Access Compliance Report

Public Rights-of-Way

Intersection ID: 48942	Main Street: MITCHELL GRANT WY	Cross Street: MORGAN LEE AV	Location: SE
ADA ID: B9A96317611A	Ramp Type: Combination2	Initial Pass/Fail: Fail	Overall Compliance: No
Severity Score: 21.25			
Codes/Mitigation Info/Possible Solution		Field Measurements/Component Compliance

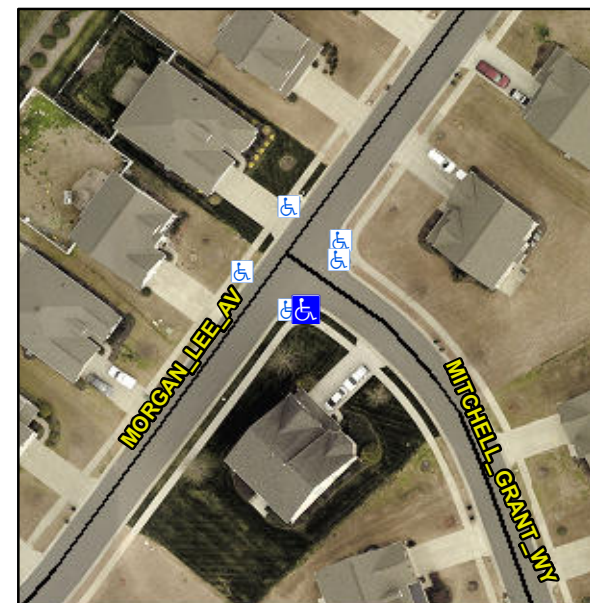
LT RP < 5%

Not Found, R304.5.1, R304.5.3

Remove & Replace Entire Ramp.
